ADDENDUM TO THE FACT SHEET
FOR NATIONAL POLLUTANT DISCHARGE
ELIMINATION SYSTEM (NPDES)
PERMIT NO. WA0037214

Facility: North End Wastewater Treatment Plant No. 3
2201 Portland Avenue
Tacoma, WA 98421-2711

APPENDIX C - RESPONSE TO COMMENTS

Figure 1. Acute and chronic mixing zone boundary for Tacoma North End Treatment Plant outfall (not to scale)

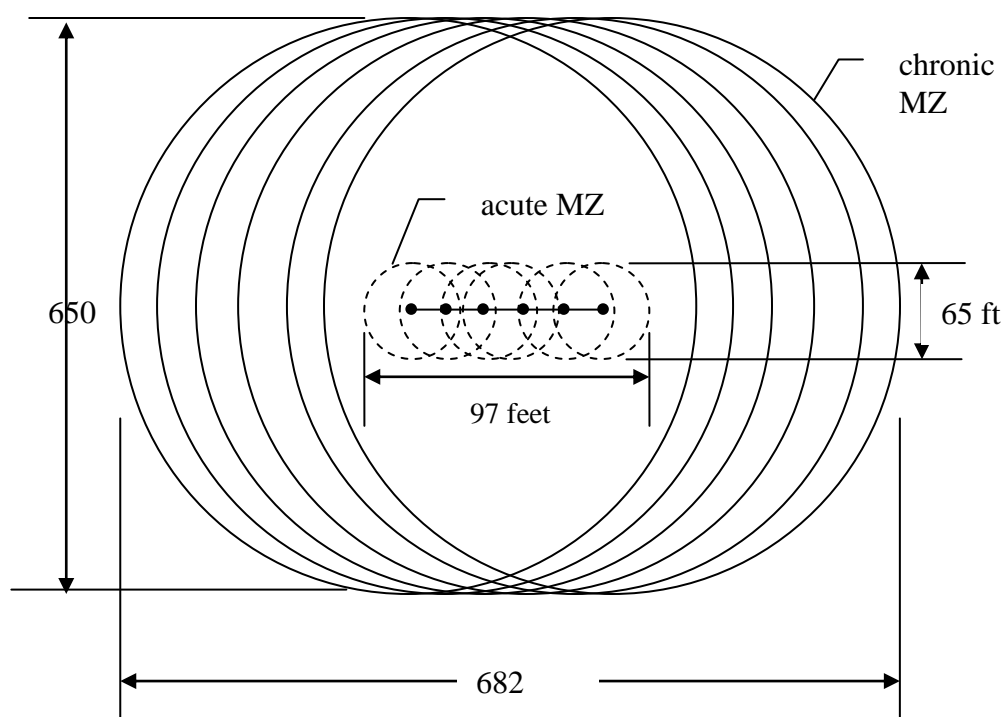
Page 7 of 38, Section S1.B: This section has been significantly changed, and there no explanation of the changes in the Amended Fact Sheet. Could Ecology explain and clarify these changes from the existing permit? What is the actual size of the entire mixing zone(s)?

Ecology clarified the size of the mixing zone based on the outfall description provided in the 1994 Engineering Report for the NETP Improvements.¹ The previous permit specified a diffuser length of 300 feet which is an error.

The chronic mixing zone is a cylinder around each discharge port (325 feet radius and 125 feet depth) rising from seabed. Given that there are six discharge ports with a total diffuser length of 32 feet, the mixing zone closely resembles an elliptical shape in plain view. The length of the shape is 682 feet ($= 325 + 32 + 325$) and width is 650 feet ($= 325 + 325$). The acute mixing zone is 10 percent of the chronic mixing zone for each discharge port (length $= 32.5 + 32 + 32.5 = 97$ feet; width $= 32.5 + 32.5 = 65$ feet). See Figure 1 for a plan view of mixing zone boundary.

Ecology did not change any dilution factors (see the original fact sheet). We specified the dilution factors in the permit for clarity.

Ecology did not make any changes to the permit due to this comment.
